**CITY OF TEMPE
DEVELOPMENT REVIEW COMMISSION**

Meeting Date: 10/27/2015
Agenda Item: 4

ACTION: Request for a Development Plan Review consisting of a new 16,013 square-foot building for CVS PHARMACY #10928 (PL150374), located at 903 East Apache Boulevard. The applicant is Withey Morris PLC.

A-4.1

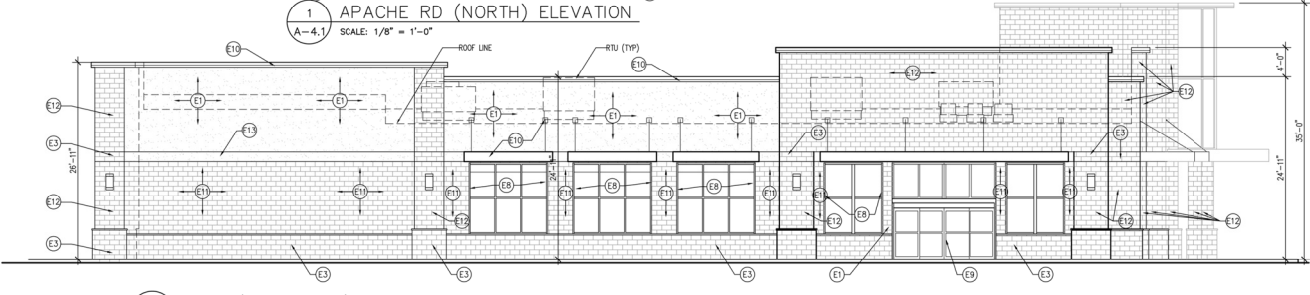
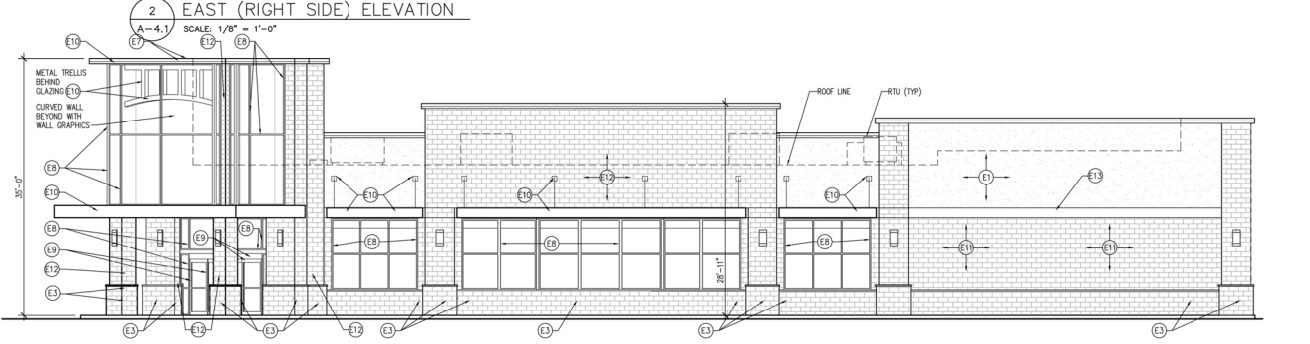
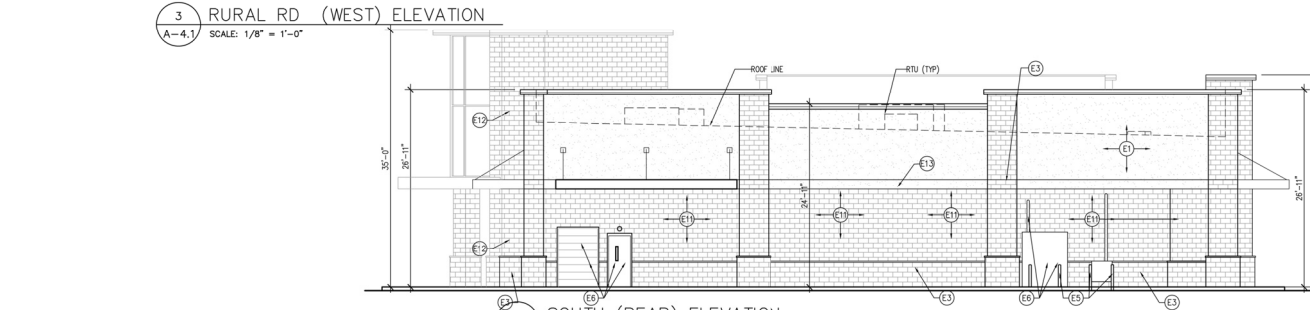
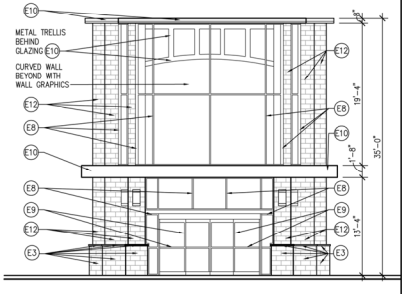
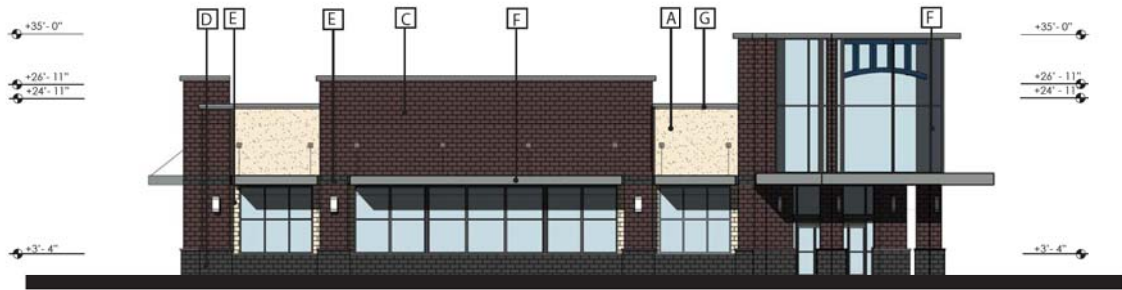
The majority of the building is going to be composed of a decorative stone veneer. The elevations depict columnar forms that start at the base but do not continue all the way up to top of building. Conditions are included to have these forms continue to the top of building to create more architectural breaks. Canopies will be aluminum with a charcoal gray finish and are located over the windows and both entrances to the building. Remaining portions of the building will be EIFS with a textured stucco finish painted to compliment the canopy structures and stone veneer. The entrance located on the corner of Rural Road and Apache Boulevard will be emphasized with a glass tower feature above the canopy structure.

13. Columnar forms on elevations shall continue to top building.
14. Provide secure roof access from the interior of the building. Do not expose roof access to public view.
